McLaren Artura – Door Stone Protection Enhancement

Bulletin type:	Service Campaign
Reference number:	N/A
Campaign reference:	SCB 16 A 001
Attention:	Retailer Aftersales Managers, Retailer Service Managers, Retailer Service Advisors, Retailer Technicians, Retailer Parts Managers
Affected vehicles:	McLaren Artura
Situation:	Enhancement of door stone protection with installation of protective gurneys
Procedure:	Action all affected vehicles. Please refer to the information outlined in this document to complete the required work
Date:	10 October 2023

1 Location of door gurney installation (1)

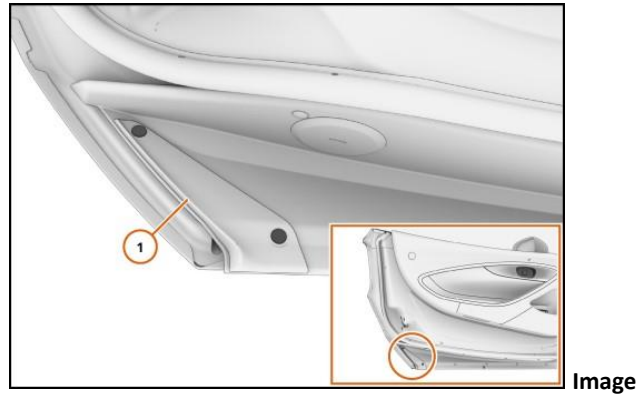
Through continuous product quality monitoring, it has been identified that due to the open duct concept of the door, debris can accumulate around the High Temperature Radiator (HTR) bezel and come into contact with the lower edge of the door causing paint abrasion. To rectify this, McLaren Automotive has released a new protective trim addition (gurney) which should be added at the lower inside edge of both doors.
